## DESIGN OBJECTIVES

## PROPOSAL

## EARLY DESIGN GUIDANCE RESPONSE

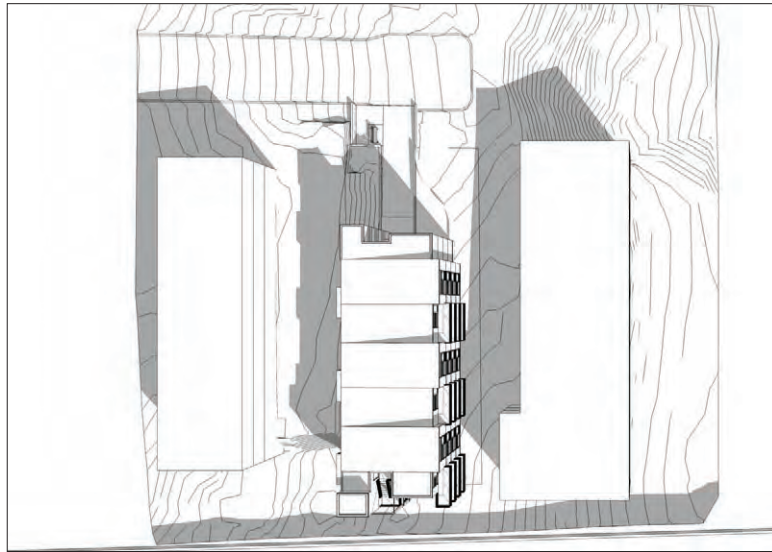
8. The eastern/western facades as viewed from NE 45th St should be carefully designed. (A-1, A-5, B-1, C-2, C-3, C-4)

*Small structures often present a design challenge as they are sometimes over-simplified to the point of being boring or overly modulated and articulated to the point of being too busy. The proposal strikes a balance by creating a simple base mass, from which, interesting modulation grows from. There are three simple bay expressions that break up the façade and provide a balanced, well-proportioned and visually interesting façade and roof line that reaches out toward the view and open space of the site.*

*There are limitations due to practical applications of what could occur on the west façade but similar treatment was incorporated here also. The bays modulate the long run of the façade and allow for maneuvering space for people moving into and out of the dwelling units, in addition breaking up what could be a long, uninteresting corridor experience.*

☀ EQUINOX - MARCH / SEPTEMBER 21 at 10am

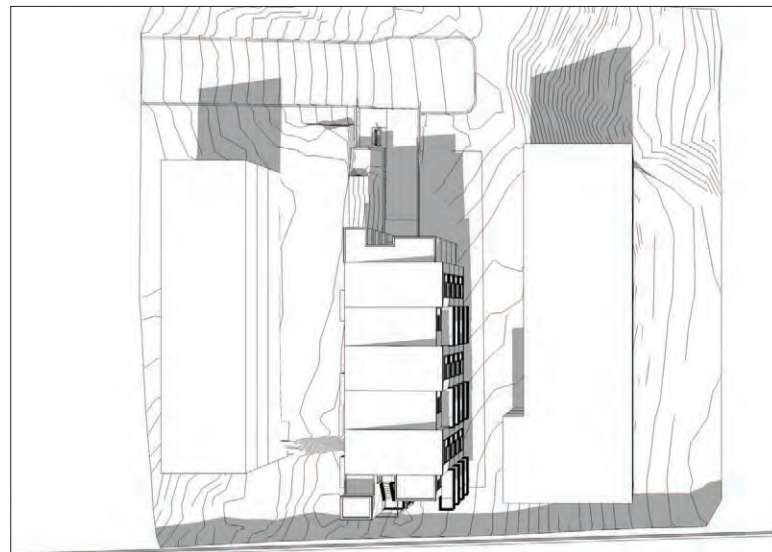
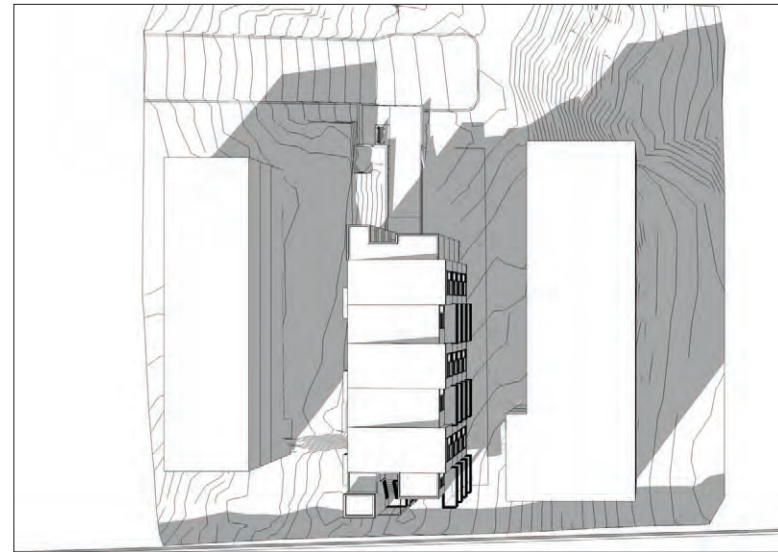
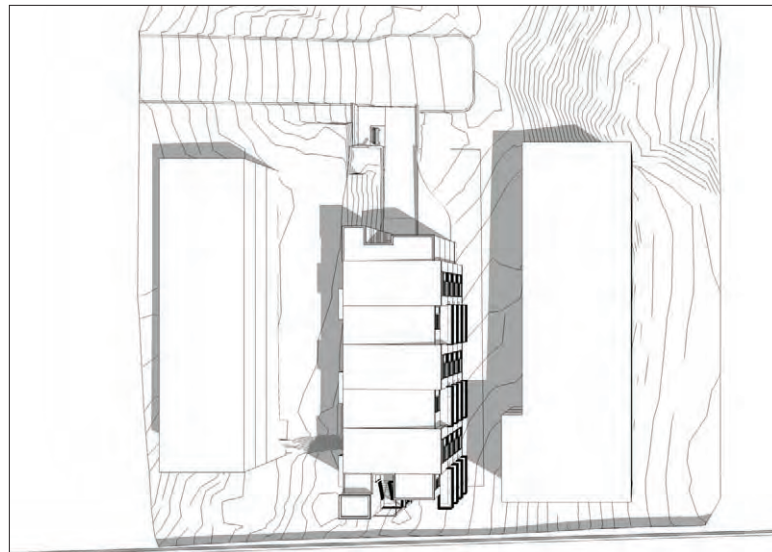
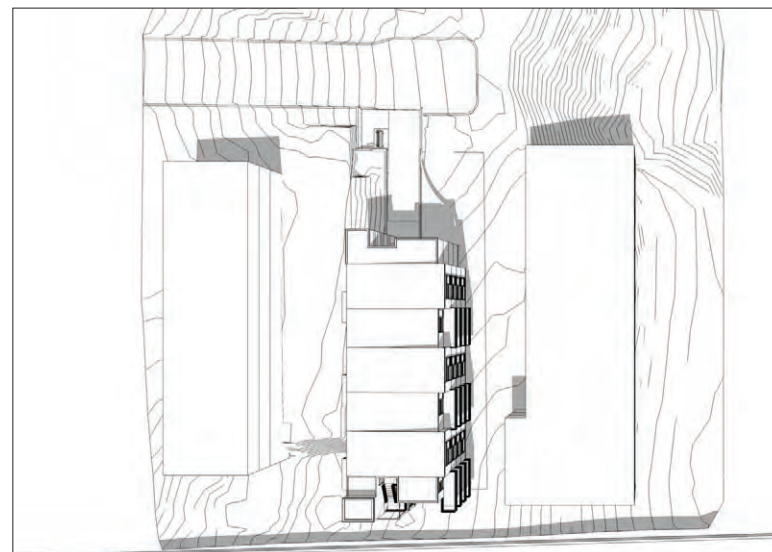
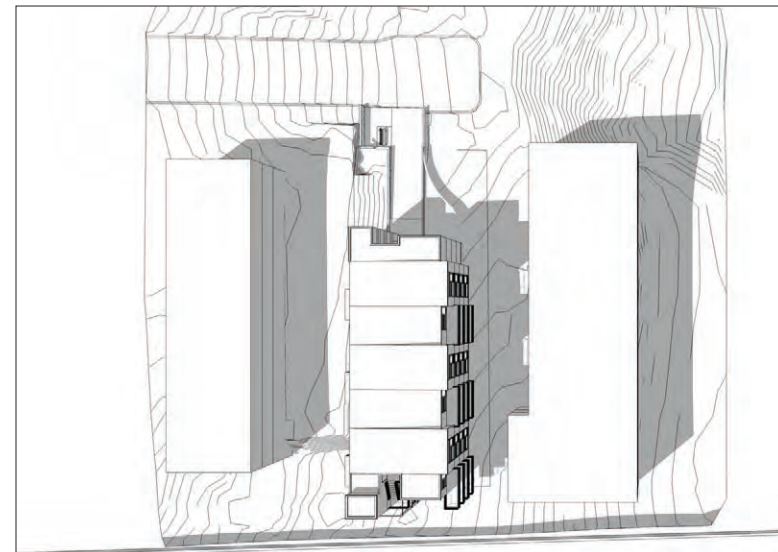
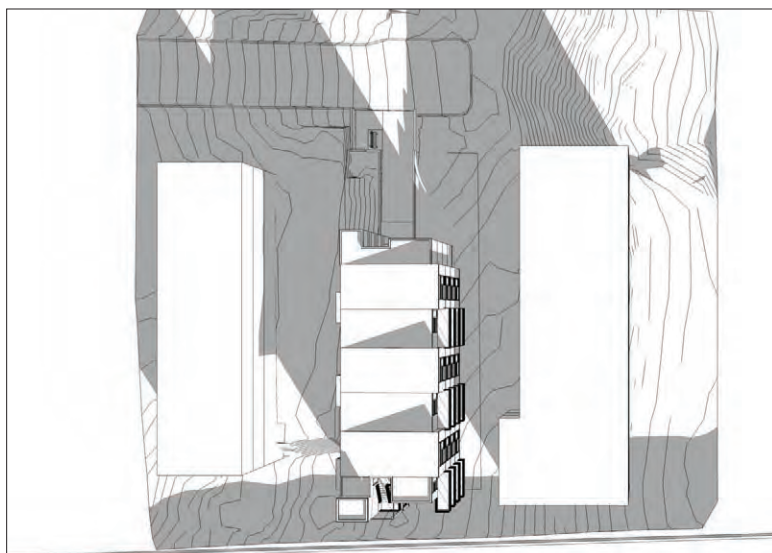
5. The Board chair noted that the applicant will need to provide shade/shadow diagrams at the future design review meetings for the bulk/scale of the structure being proposed. (A-1, A-5, A-6, B-1, C-2, D-1, D-7, E-2, and E-3)

*Noted.*
